AMENDMENT NO. 1 JULY 2023

IS 6392: 2020 STEEL PIPES FLANGES — SPECIFICATION

(First Revision)

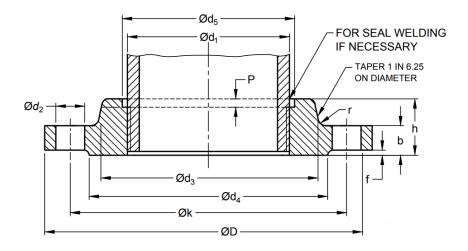
(Page 50, Table 39, Figure) — Substitute the following with existing:
